COMMITTEE FOR  
GREEN FOOTHILLS

Re: Lands of Mazzone, PDC 13-028

This constitutes the comments of Committee for Green Foothills on the Initial Study and Mitigated Negative Declaration for the above-referenced project. Committee for Green Foothills works to preserve open space and natural resources, including creeks and wildlife, in San Mateo and Santa Clara Counties. We have a strong interest in the riparian corridors of San Jose and in the enforcement of the riparian setback requirements that protect those corridors.

Santa Clara Valley Habitat Plan Figure 6-2, “Stream Setback Requirements for Category 1 Streams” (portion of map, enlarged)

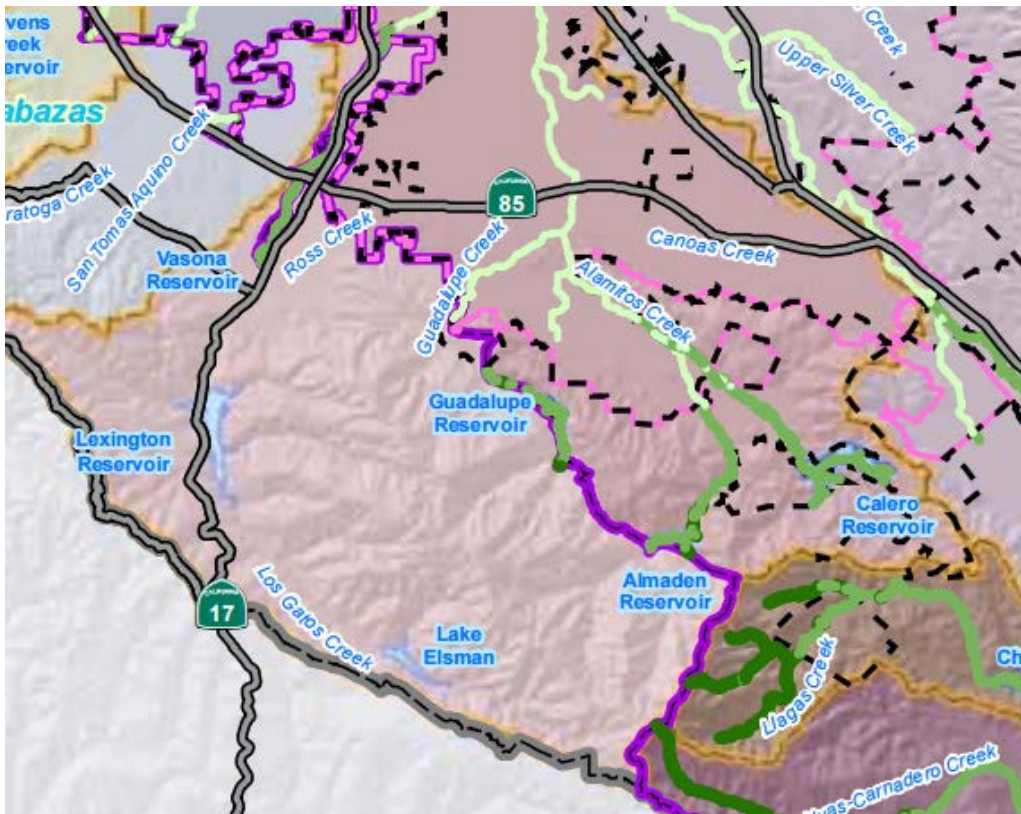
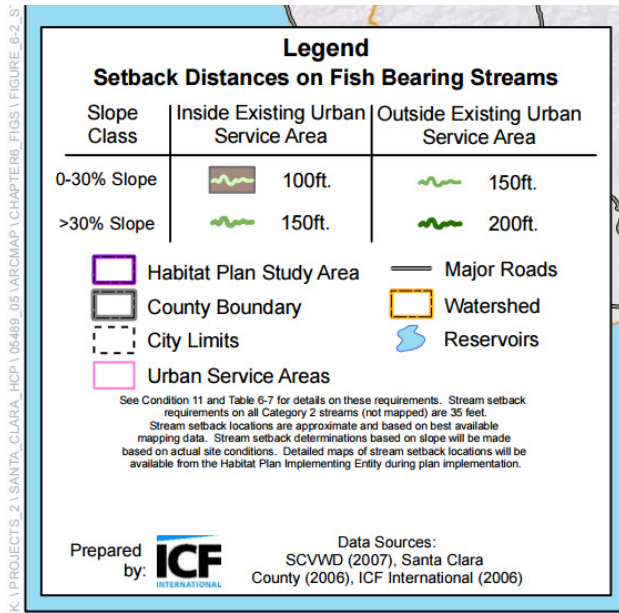
Regardless of anyone's opinion of whether or not Golf Creek fits the definition of a Category 1 stream, the fact remains that it is so listed in the SCVHP. The attached image shows a portion of Figure 6-2 of the SCVHP, "Stream Setback Requirements for Category 1 Streams." Although Golf Creek is not labeled in Figure 6-2, it is clear from the map, based on the location of Alamitos Creek as well as the surrounding creeks and roadways, that the reach of Golf Creek just before it meets Alamitos Creek is depicted on Figure 6-2 as a Category 1 stream.

The MND points to the fact that Golf Creek is undergrounded for part of its length in support of its argument. Again, a glance at Figure 6-2 shows that only part of Golf Creek is represented on this map as a Category 1 stream. Where Golf Creek disappears underground, it also disappears from Figure 6-2. Therefore, the MND's statement that the undergrounded portion of Golf Creek is "yet mapped as Category 1" is incorrect.

The SCVHP requires riparian setbacks of 100 feet from Category 1 streams and 35 feet from Category 2 streams. The MND attempts to treat Golf Creek as a Category 2 stream, which would require only a 35-foot setback. As a result, the mitigation measures required in the MND fail to fully mitigate the impacts of the project.

The MND must be revised to reflect the reality of Golf Creek’s classification as a Category 1 stream under the SCVHP. Thank you for your consideration of these comments.
